LINCOLN CITY/LANCASTER COUNTY PLANNING STAFF REPORT

for July 9, 2003 PLANNING COMMISSION MEETING

P.A.S.: -Annexation #03004 - To annex approximately 13.3. acres.
 -Change of Zone #3387 - From AGR to R-3
 -Special Permit #1992 - For a Community Unit Plan (CUP) for attached and detached single-family residences.
 -Preliminary Plat #02023 Edenton Woods - Creates 46 lots for residential development, and five outlots.

To: Brian Will, Planning Department
From: Chad Blahak, Public Works and Utilities
Subject: Edenton Woods Preliminary Plat and Special Permit
Date: 6/27/03
cc: Randy Hoskins

Edenton Woods
SITE PLAN
Lincoln, Nebraska

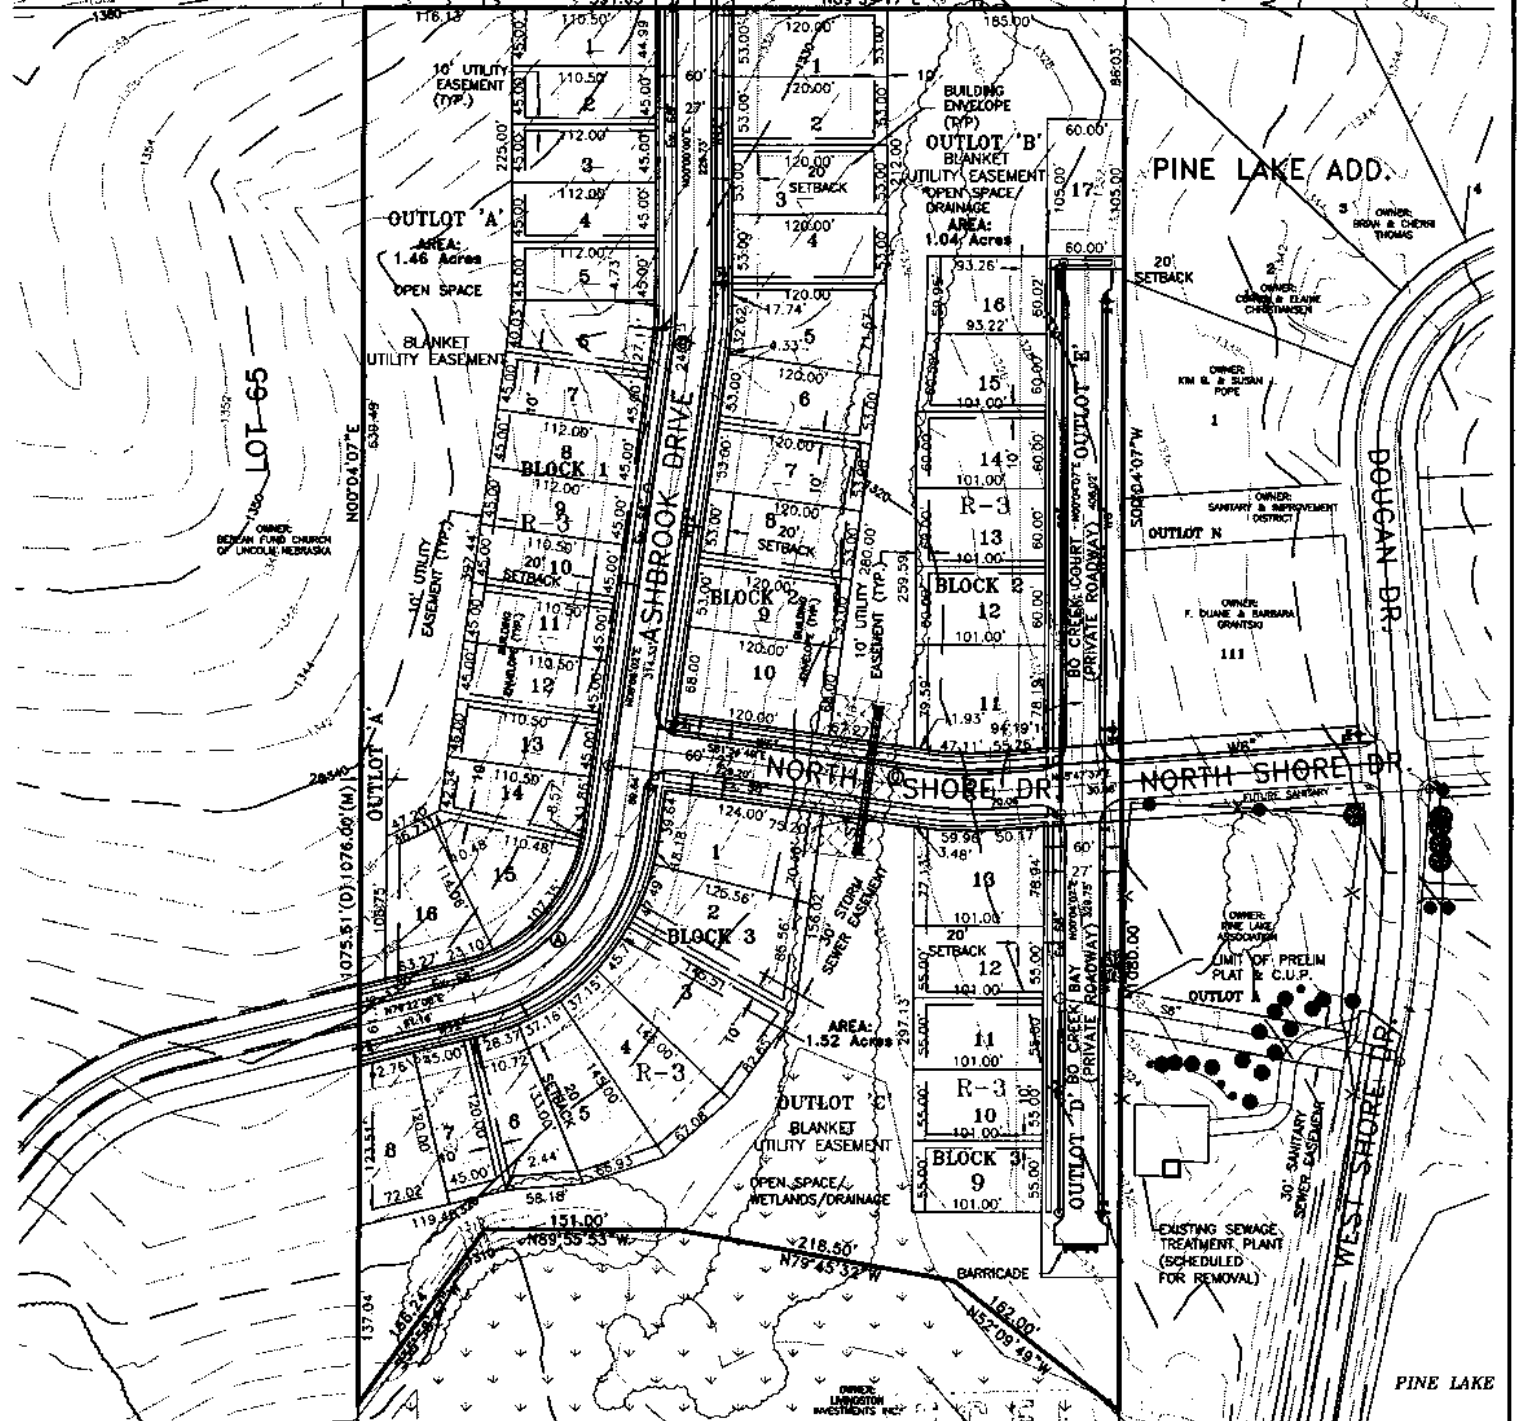
4. A waiver to turn-arounds was requested, and pertains to Bo Creek Bay and Bo Creek Court. However, the Design Standards do not include a specific requirement that turn-arounds be provided for private roadways so a waiver is not required. But recognizing the need for all vehicles including emergency responders to be able to turn around at the end of a street without either backing-up or pulling into a driveway, a minimum 30' radius turn-around is recommended. The plat shows hammerhead turn-arounds at the ends of both streets, but should be revised to show 30' radius cul-de-sacs.

- The turnarounds in Bo Creek Court and Bo Creek Bay do not meet subdivision requirements. It appears that 30' radius turnarounds would fit at both ends. The plans should be revised to show 30' radius turnarounds. A barricaded dead-end for a permanent turnaround is unsatisfactory.

- 1.1.5 Turn-arounds with a minimum 30' radius at the ends of both Bo Creek Bay and Bo Creek Court.
 - 1.1.6 Utility easements required by the June 12, 2003 L.E.S. review.
